Addendum

Date August 18, 2026
Project Name Oakland University – Aquatic Center Renovation 2027
TMP Project No. 26037
Addendum No. Three (3)

DRAWING NO.
AQ2.0

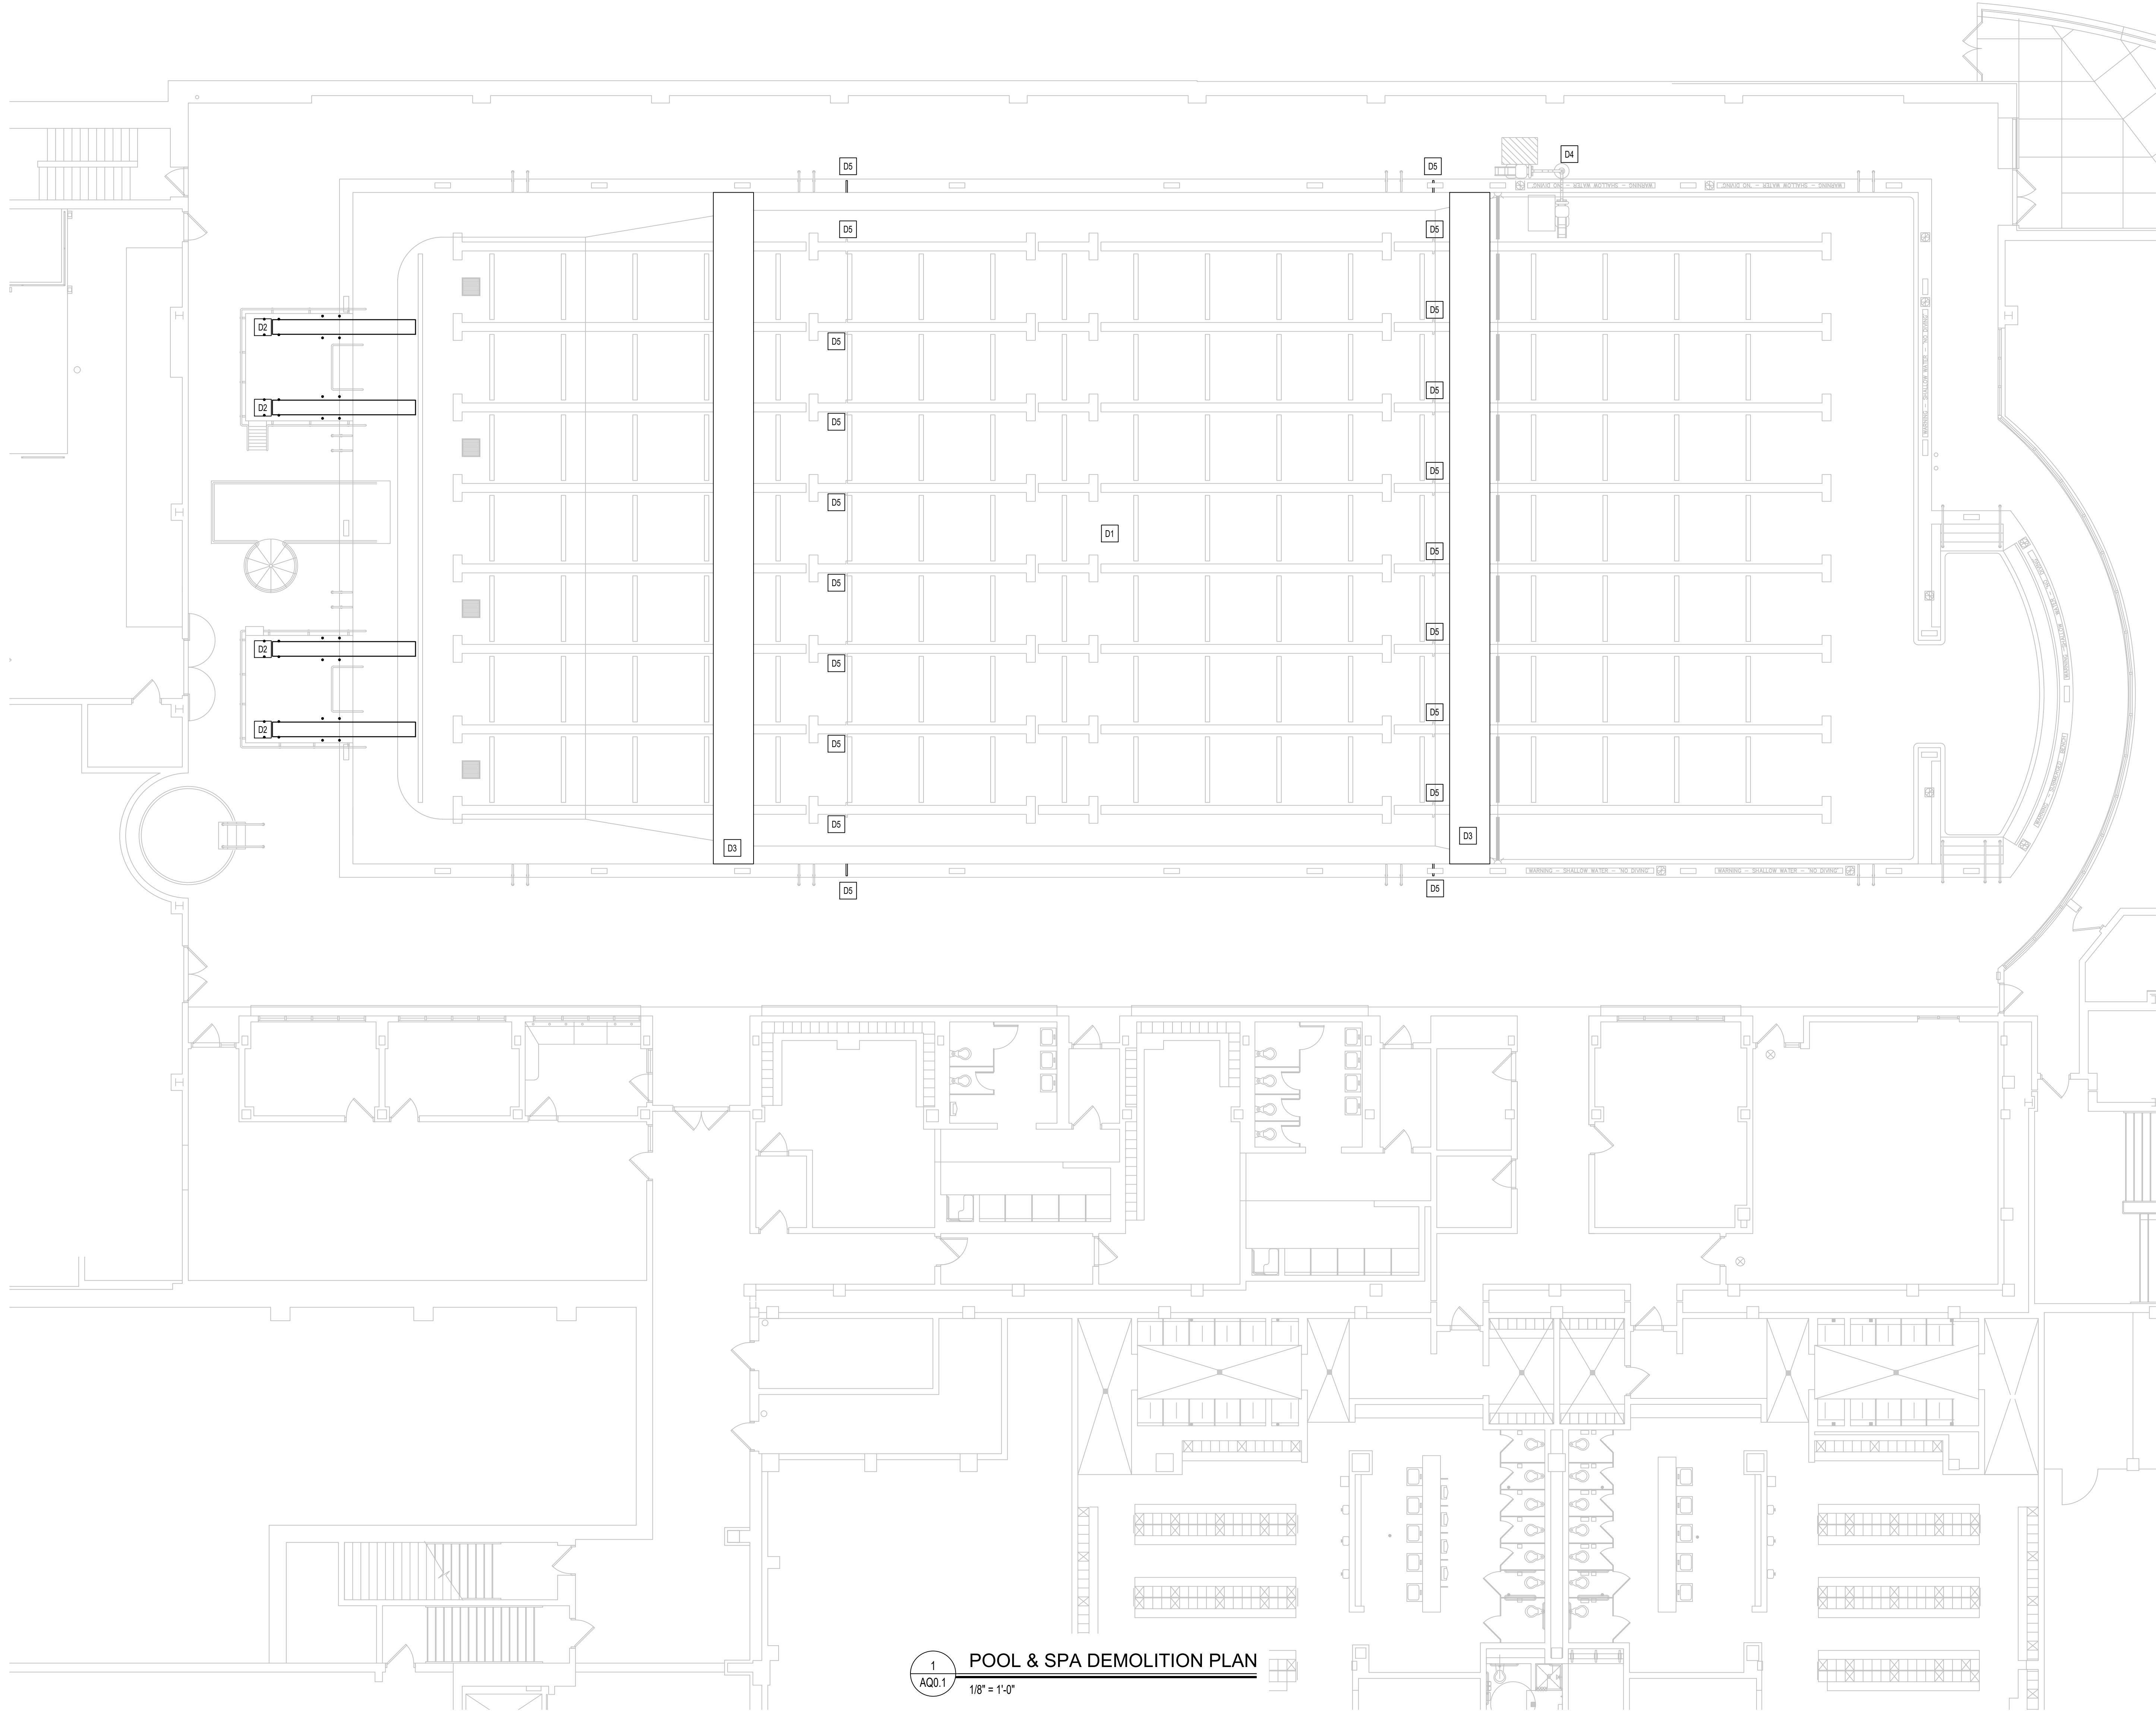
- AQ-6 Refer to Drawing No. AQ2.0 (reissued):
- A. UV cabinet location revised to southwest wall of mechanical room.
 - B. Filter backwash piping clarified.
 - C. Flow meter sensor and impact flow meter locations revised.
 - D. Equipment schedule items added for new surge tank hatch and ladder.
 - E. Water level controller box tagged on plan.

AQ0.1

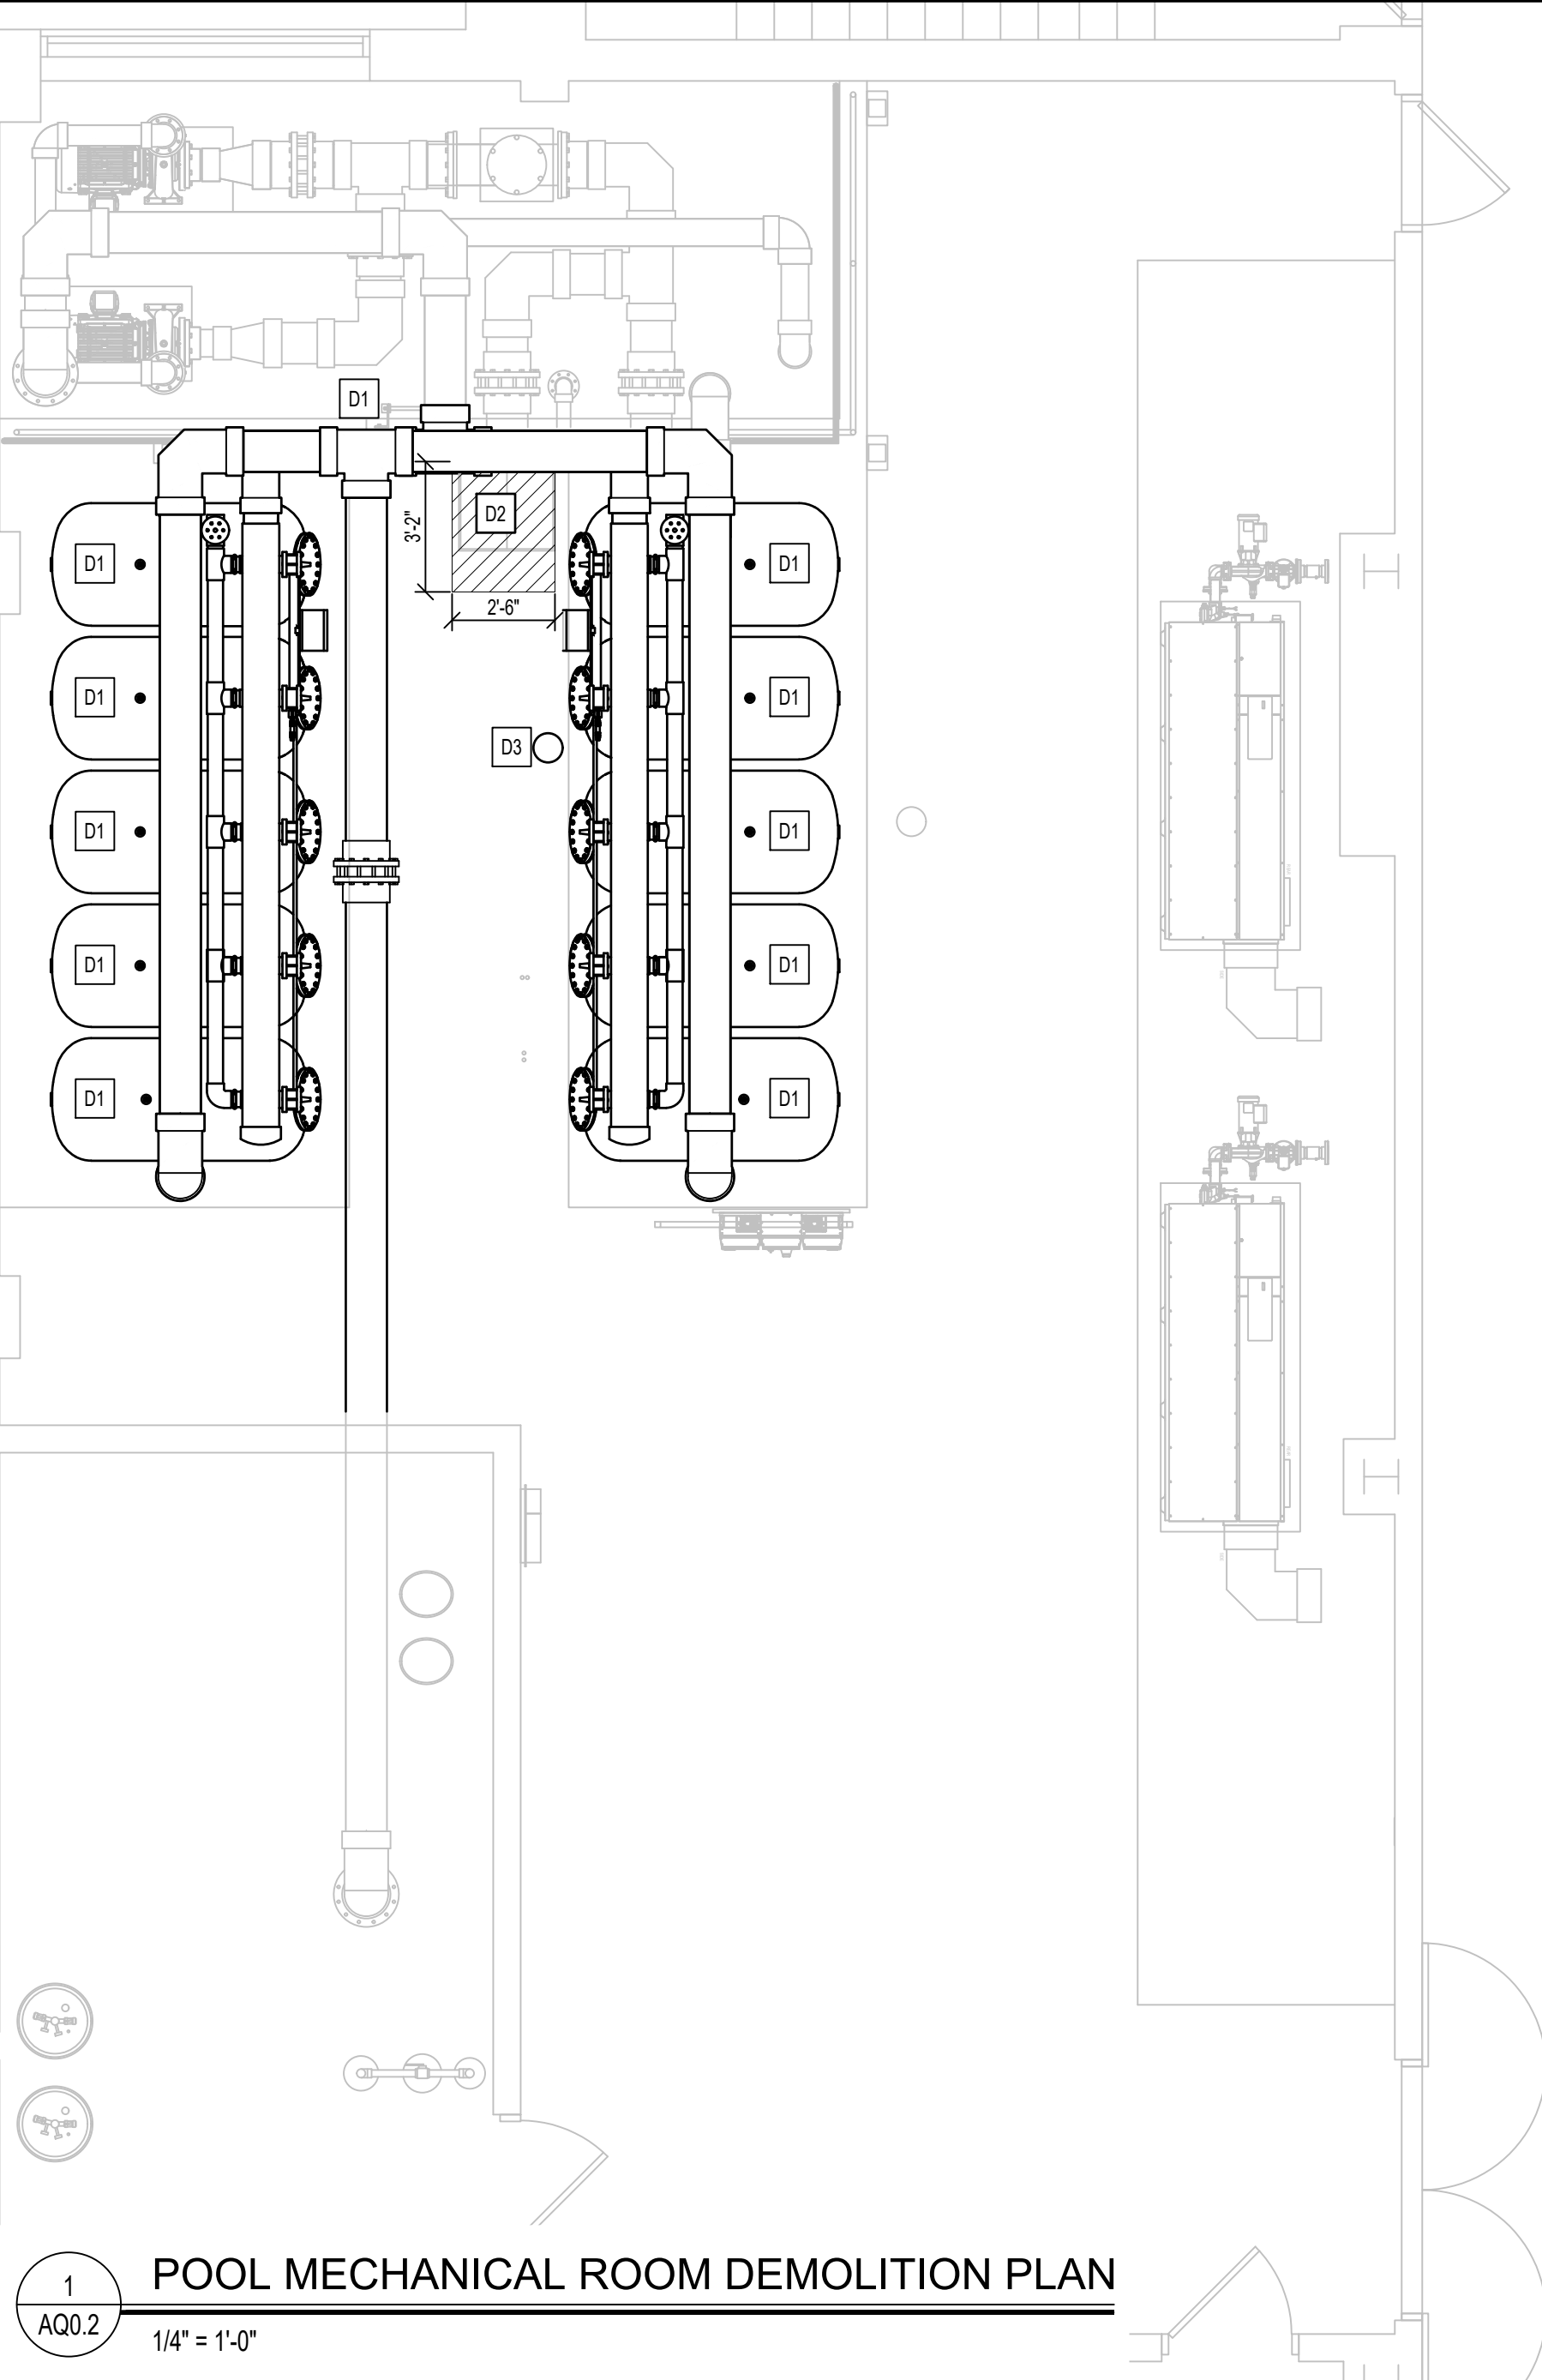
Item No.	Aquatics Drawing Changes
AQ-1	Refer to Drawing No. AQ0.0 (reissued): A. Updated graphics to reflect changes made on other drawings in the Addendum.
AQ-2	Refer to Drawing No. AQ0.1 (reissued): A. Demolition note D5 clarified to indicate removal of existing tile for new resurfacing markings as indicated.
AQ-3	Refer to Drawing No. AQ0.2 (reissued): A. Demolition note D2 clarified to indicate removal of existing surge tank ladder rungs.
AQ-4	Refer to Drawing No. AQ1.0 (reissued): A. Renovation note R9 added for new resurfacing marking. Dimensions from pool wall revised.
AQ-5	Refer to Drawing No. AQ1.2 (reissued): A. Details 1 and 2 revised to clarify existing conditions and extent of new pool wall finish.

2 FILL FUNNEL
AQ2.1 3/8" = 1'-0"

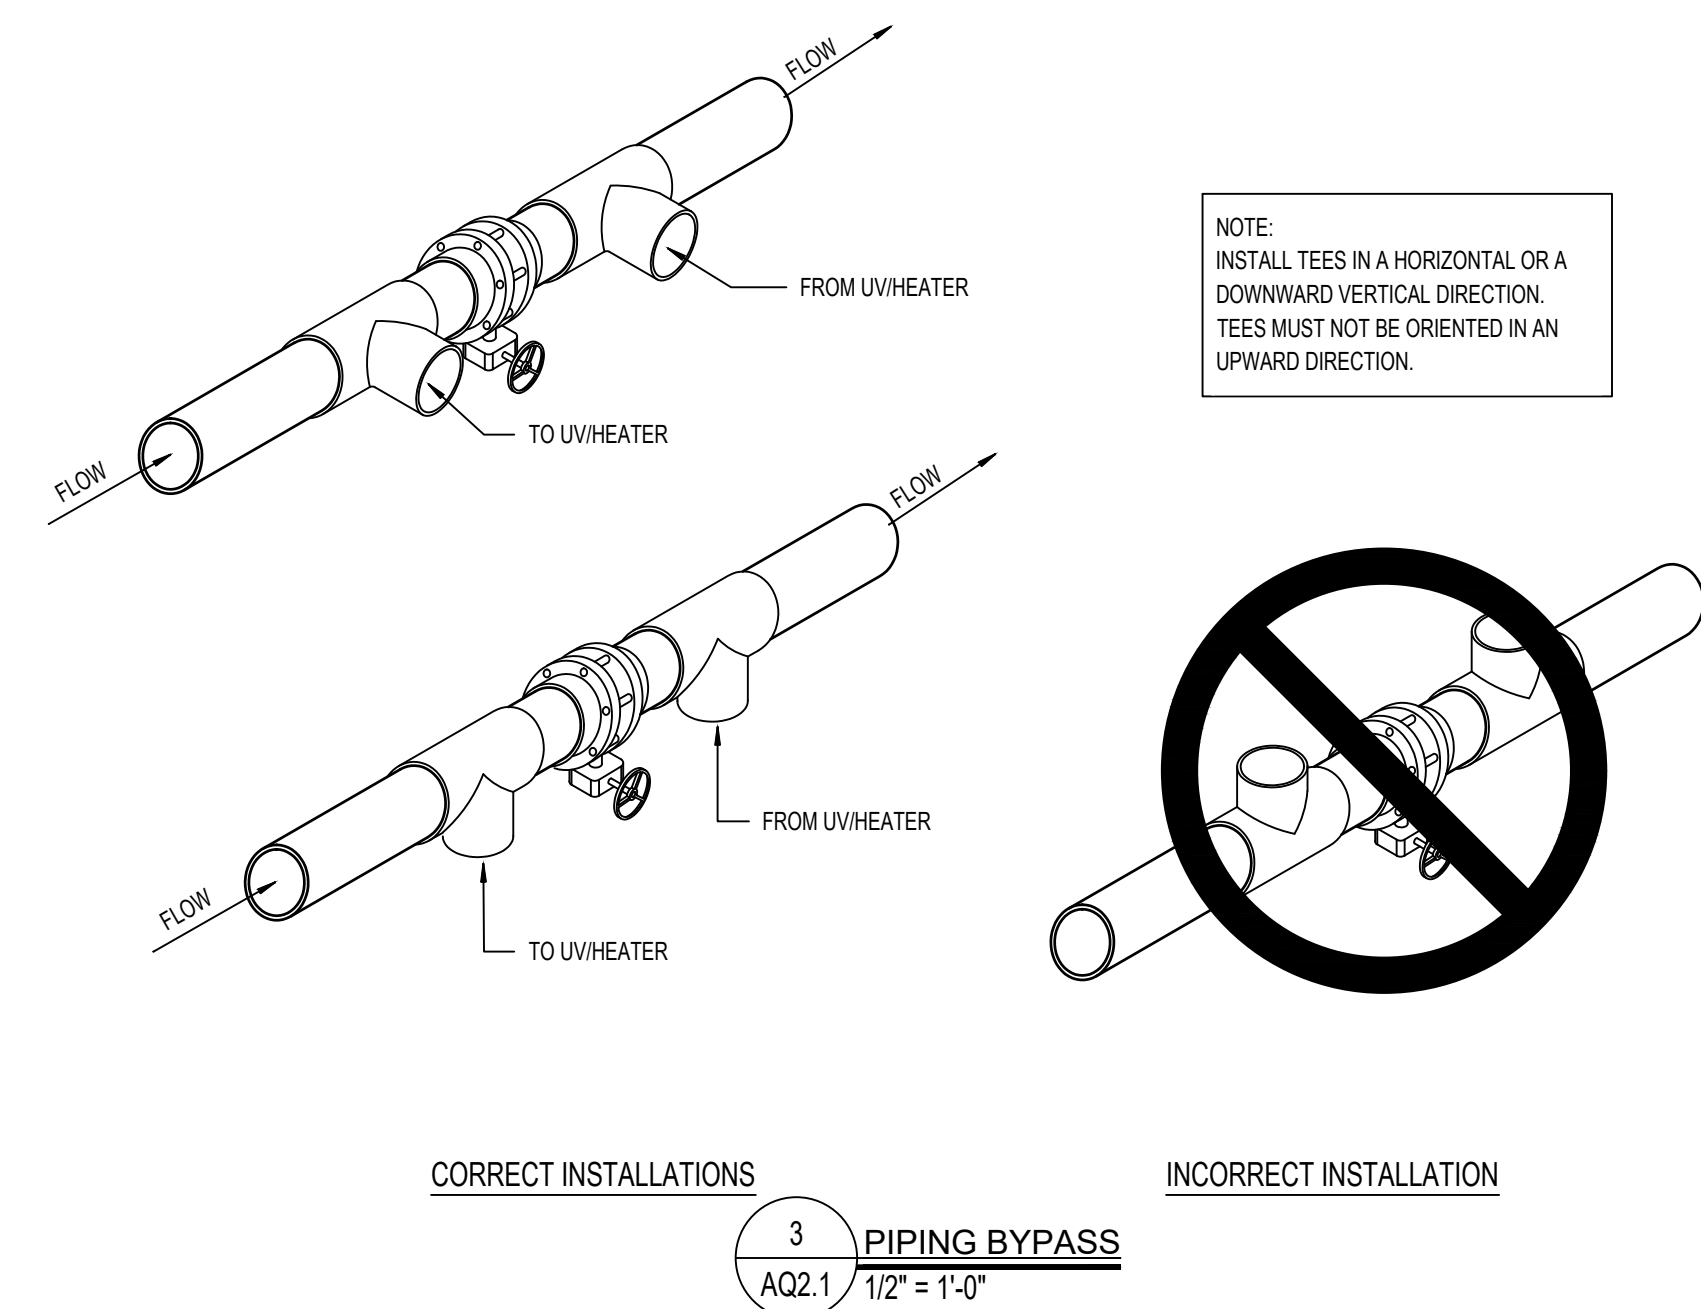
- AQ-7 Refer to Drawing No. AQ2.1 (reissued):
- A. Detail 2 note revised to clarify that the existing fill funnel will remain.

NOTE:
PLUMBING CONTRACTOR MUST PROVIDE DOMESTIC WATER SERVICE PIPING TO AIR GAP, WATER METER, AND BACKFLOW PREVENTER (IF REQUIRED). PLUMBING CONTRACTOR MUST INSTALL SOLID VALVES FURNISHED BY THE POOL CONTRACTOR. EXISTING FILL FUNNEL TO REMAIN.
